**YARRA CITY COUNCIL**  
**Internal Development Approvals Committee**  
**Agenda**

Item		Page	Rec. Page
1.1	178-182 Johnston Street, Fitzroy VIC 3065 - Planning Permit Application No. PLN16/0563 – Demolition of the existing buildings, the construction of a seven storey building plus two basement levels, the use of the land as dwellings, a reduction in the car parking requirement and a waiver of the loading bay requirement associated with shops.	5	35
1.2	PLN15/0800 - 359 St Georges Road, Fitzroy North	128	155

1. This report provides Council with an assessment of planning permit application PLN16/0563 and recommends Council's position at the Victorian Civil and Administrative Tribunal be of support, subject to conditions.

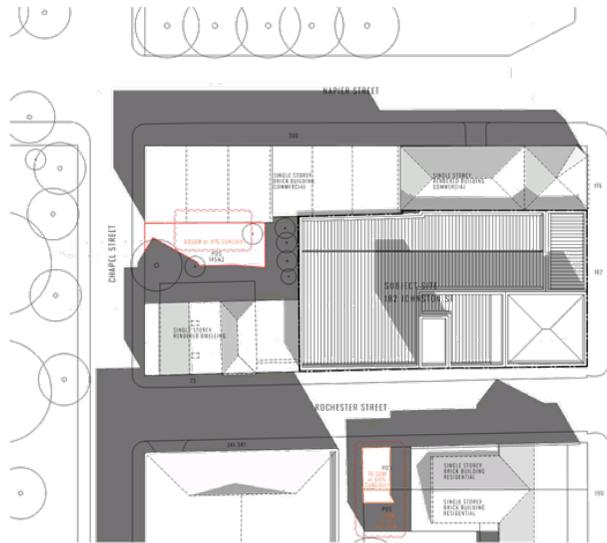
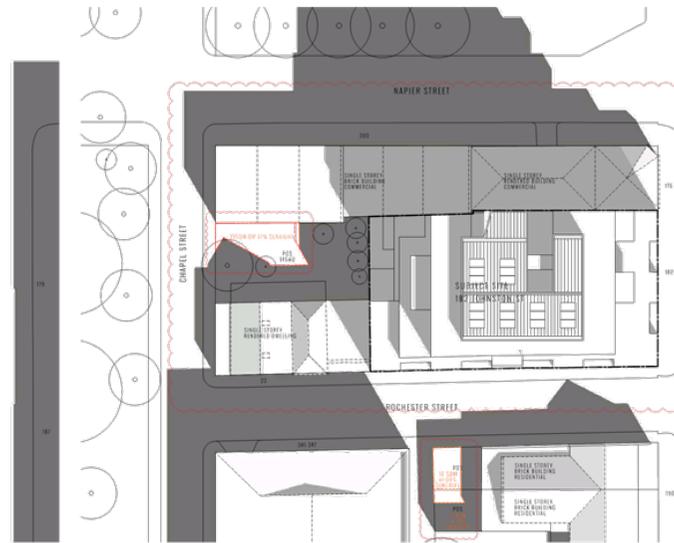
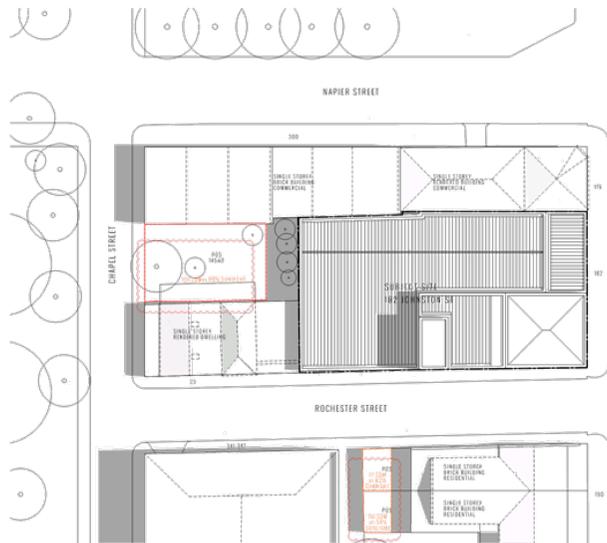
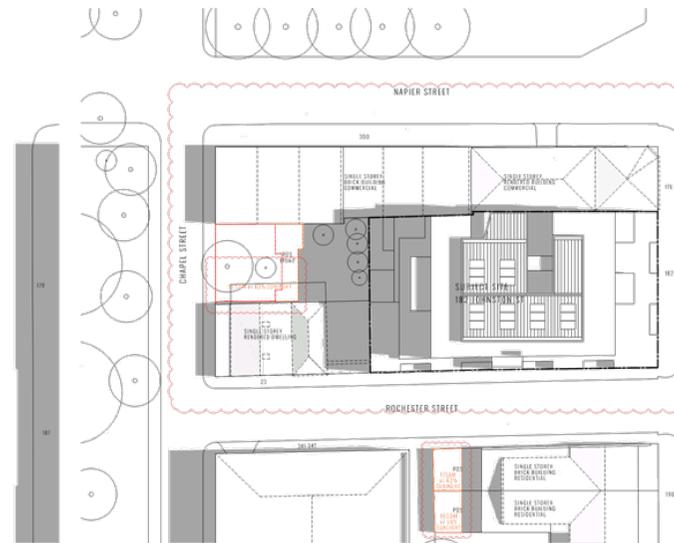
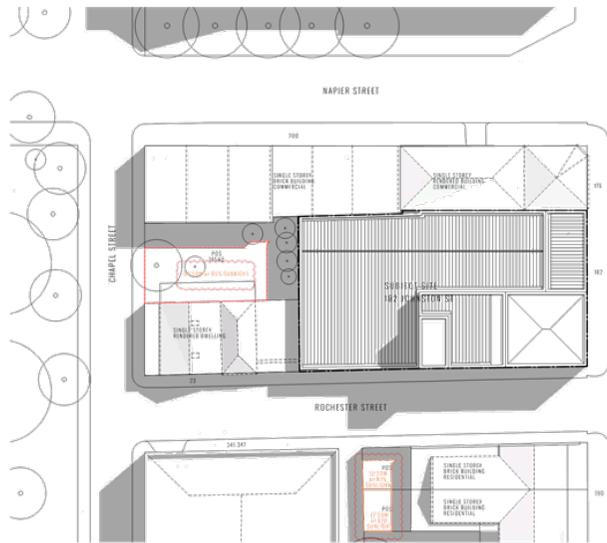
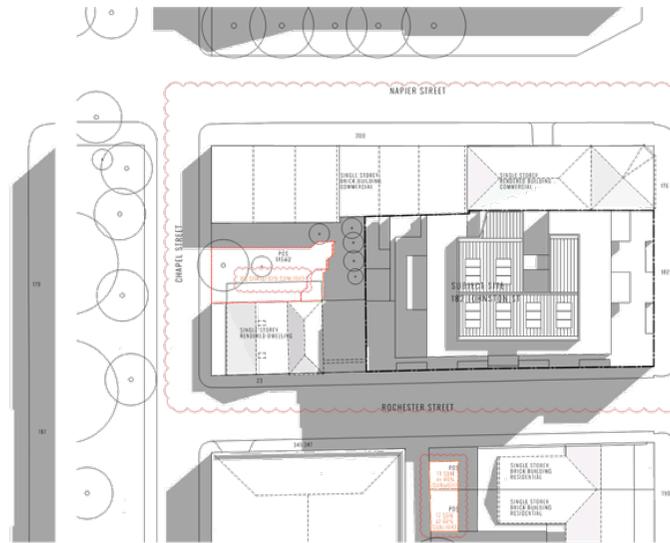
132. The shadow diagrams submitted with the substituted plans show that the extent of additional overshadowing as a result of the proposed development is minimal. Specifically, the amount of additional shadow cast on the secluded private open space of the dwelling at 23 Chapel is compliant with the overshadowing standard of Clause 55.04-5 of the Scheme as more the 40 square metres retains sunlight for five hours between 9:00am and 3:00pm, even though this requirement does not strictly apply in this instance.

Figure 1 – Johnston Street viewline assessment with recommended setback and height reductions

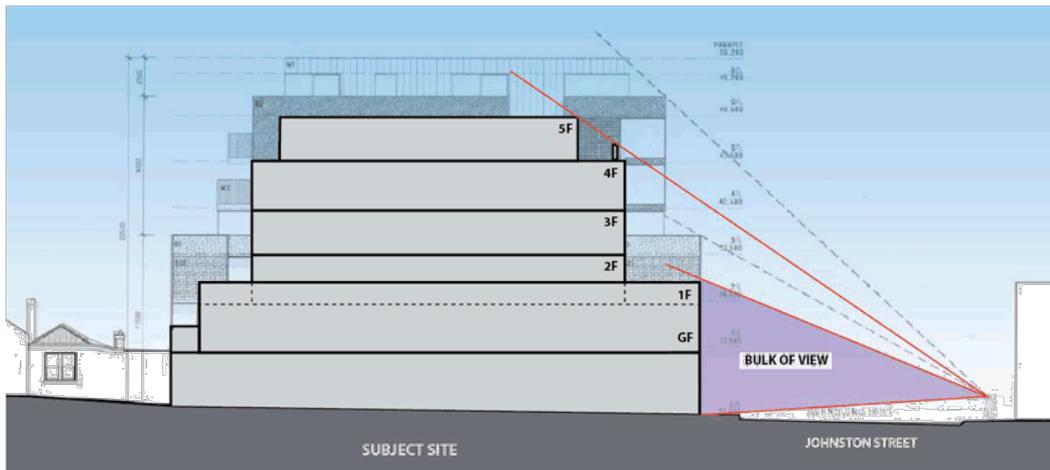
The recommended reduction of the proposed streetwall height will increase the visibility of the proposed upper form as viewed from the public realm, which is at odds with the intent of the DDO. Therefore, an appropriate response to upper form visibility in relatively intact heritage streetscapes (such as the southern side of Johnston Street) is to limit it to no more than a modest percentage of the overall visibility of the proposal as viewed in direct views from the public realm. Figure 1 below tests this from Johnston Street, Rochester Street and Napier Street.

Based on this – combined with the policy guidance of DDO10 and Clause 22.02 – the visual presence of the upper form is excessively disproportionate to the immediate context and should be reduced accordingly. We recommend deleting the proposed Level 6 and setting back Level 5 so that it is not visible in direct views from both Johnston Street, Rochester Street and Napier Street. Levels 2-4 should also be set back a minimum of 5m from Johnston Street. Doing so will ensure an appropriate built form response consistent with surrounding character and the intent of both DDO10 and Clause 22.02.

Above: Extract from St Georges Road street elevation endorsed drawing for PLN14/0100 336-338 St Georges Road -

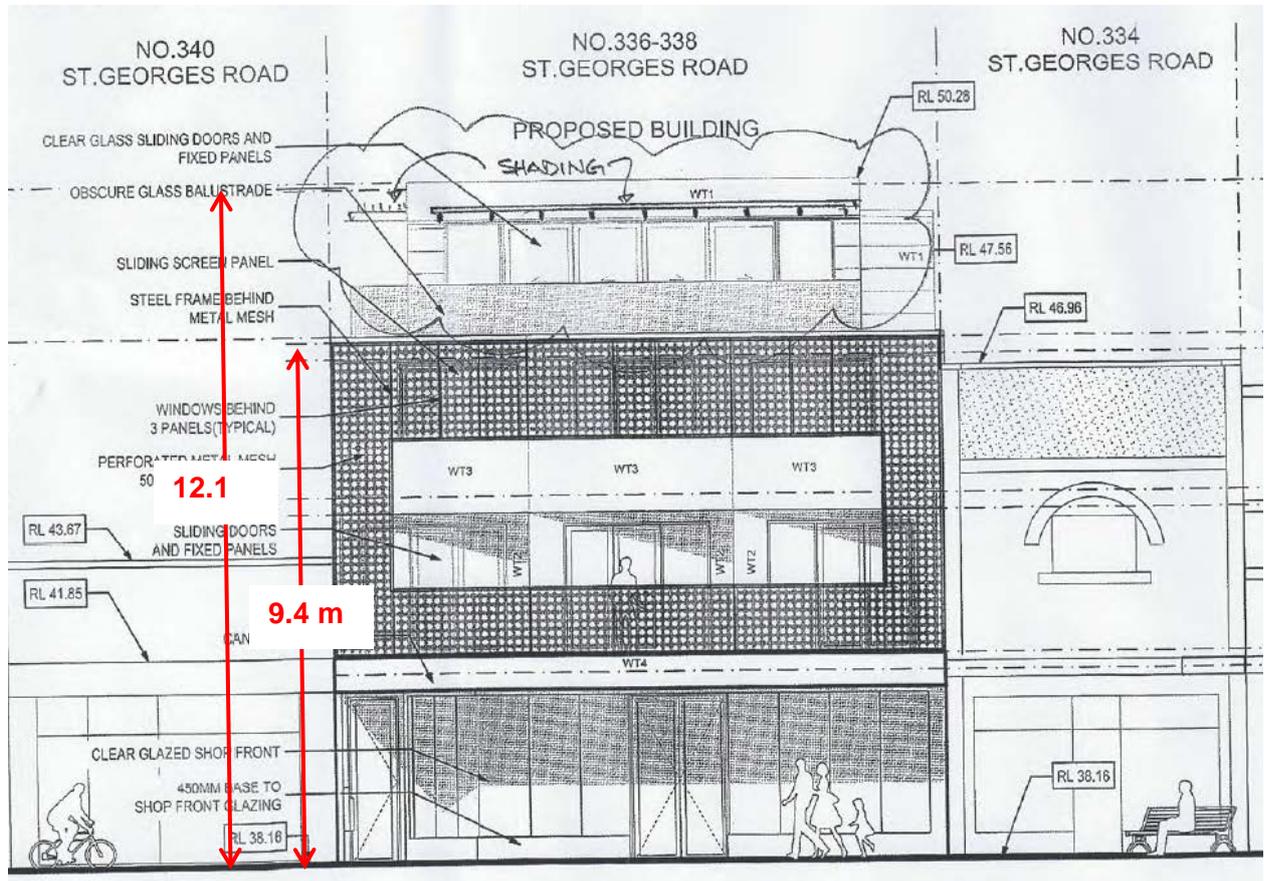
It should also be noted approval for a building of similar scale has recently been approved on the opposite side of the street (refer to diagram below). For comparative purposes, the currently proposed building façade will be about 0.3 mm higher than the building opposite. The overall height of the currently proposed building will about 1 metre taller than the approved building however it should be noted that the subject building appears to have an 800mm high parapet above the top floor which is creating unnecessary additional height. It is therefore considered that **the proposed parapet detail above the uppermost floor level must be deleted.**
